**CITY OF MIDLAND, TEXAS
AGENDA FOR PLANNING AND ZONING COMMISSION
MEETING
July 6, 2026 - 3:30 PM
300 North Loraine
Midland, Texas
Council Chamber - City Hall**

Item Number: 3.
Meeting Date: July 6, 2026
To: Planning and Zoning Commission
From: Lori Elliott, Planner
Subject: Motion approving a Final Plat of West 191 Industrial Park, Section 18, being a replat of Lot 1A, Block 3, West 191 Industrial Park, Section 10, City and County of Midland, Texas. (Generally located on the north side of State Highway 191, approximately 1,780 feet east of North Farm to Market Road 1788.)

Item Number: 4.
Meeting Date: July 6, 2026
To: Planning and Zoning Commission
From: Lori Elliott, Planner
Subject: Motion approving a Final Plat of South Park Addition, Section 9, being a replat of Lot 1, Block 4, South Park Addition, City and County of Midland, Texas. (Generally located at the southwest corner of the intersection of East Dakota Avenue and South Atlanta Street)

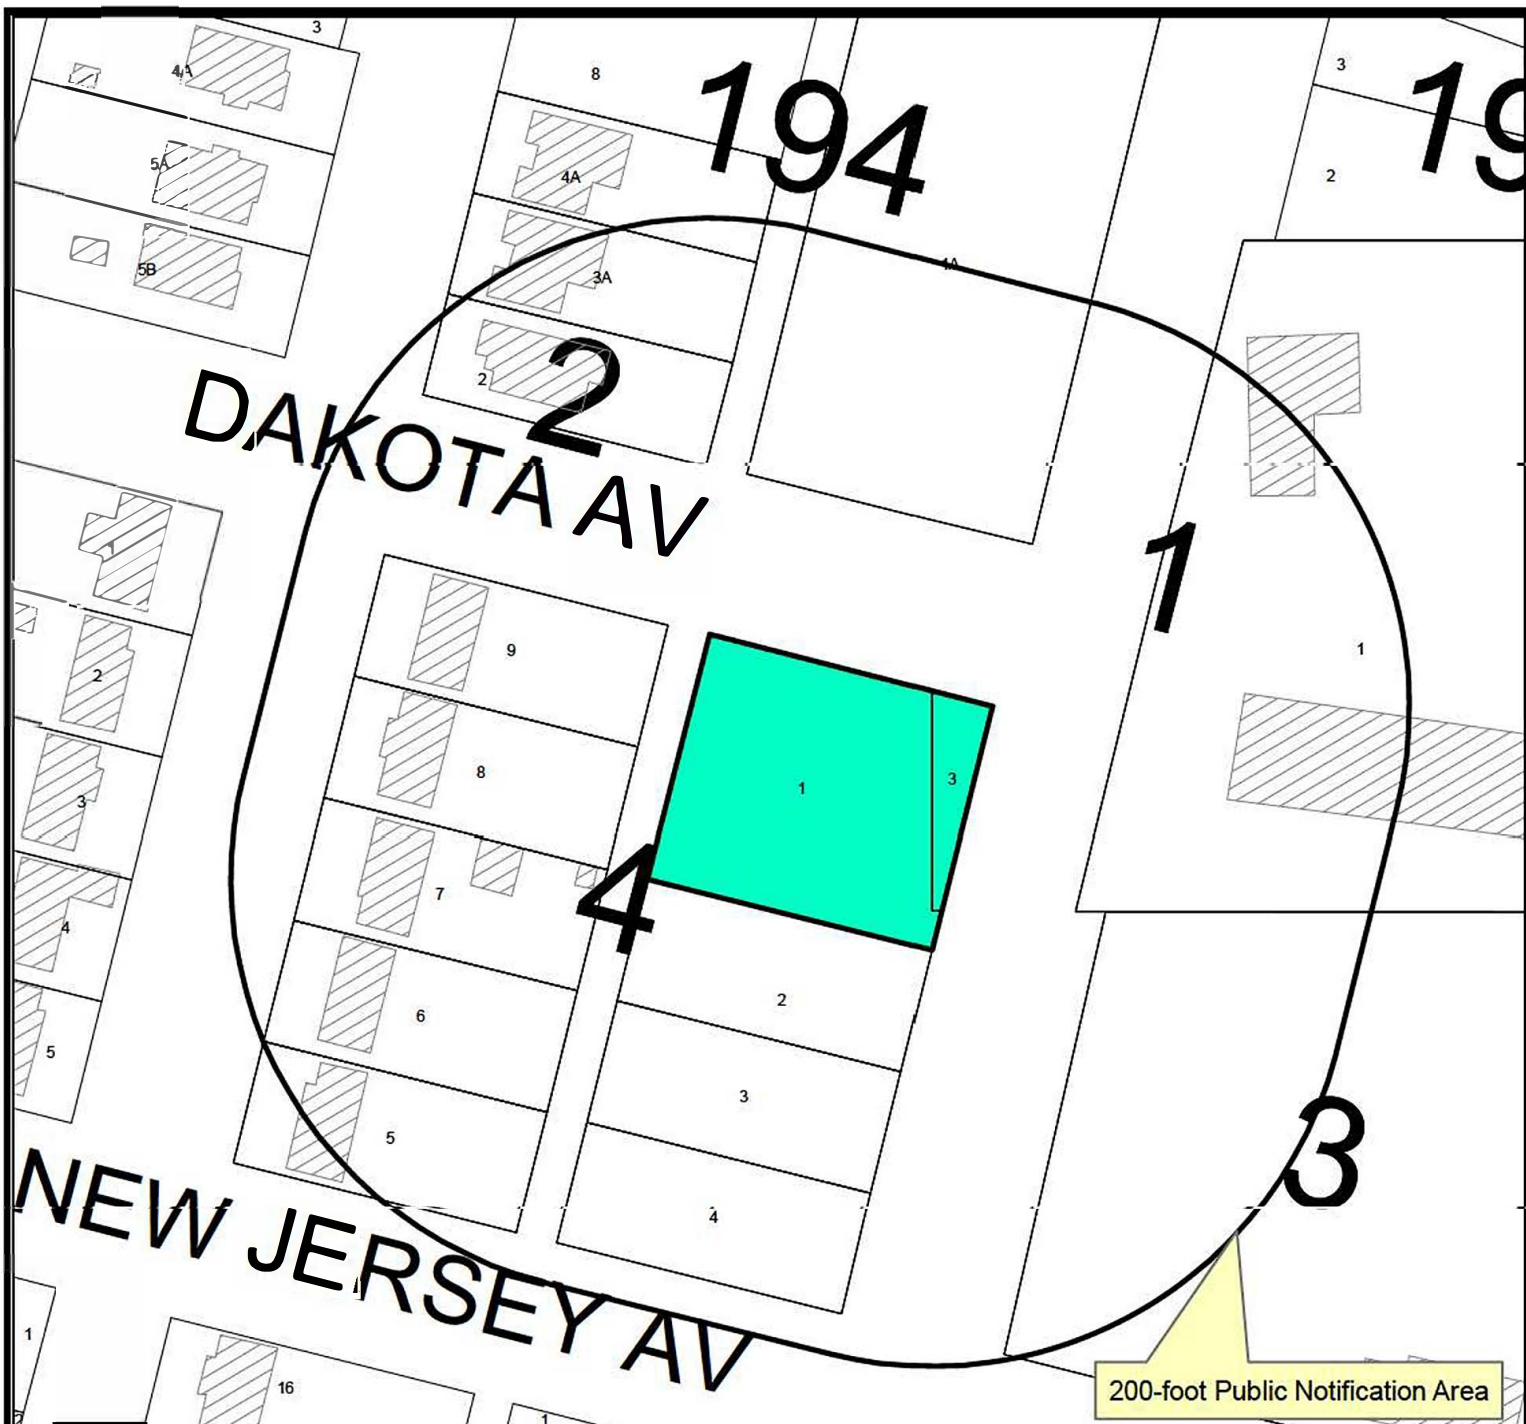
I do not see the changes from prelim plat changed. Previous Comments: Directional & Suffix need to be added to "Atlanta". S/B "S Atlanta St". New Lots s/b Lot 1A and 1B, not 4A & 4B. Replat Legal Info references wrong Lot #, states "4" s/b "1". It also does not reference the city. Verify w/Domingo. GIS System needs to be verified on the intersection of E Dakota Ave and S Atlanta St area.

Check legal description. Lot number appears incorrect. Confirm that the portion in Primitive Baptist Church is a tract and not a lot (based on deed). Label surrounding subdivision names. Lot numbers would be 1A and 1B. Section number can be 9. Legal should show that plat is in the City. Add direction and street type to Atlanta.

WARFIELD INDUSTRIAL PARK SECTION 3

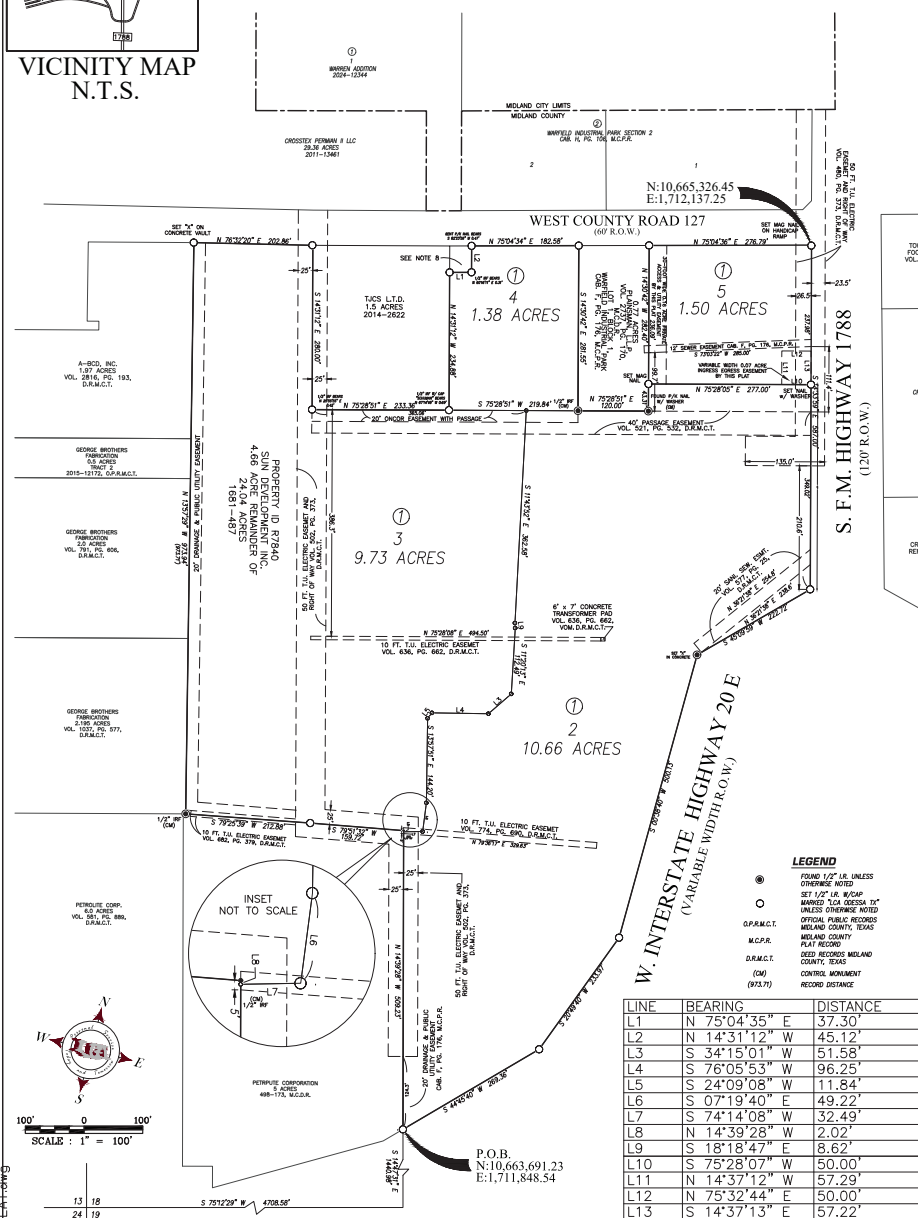
Depict City Limits. Request property corners from City Surveyor. Current bounds and plat bounds are 12' apart. Need confirmation. Label surrounding subdivisions and their lot/block info. Metes and bounds and plat visual calls should match. (last call is slightly off) Add direction to street name. 12' sewer easement in Lot 5 needs recording info. W I20 E appears mislabeled.
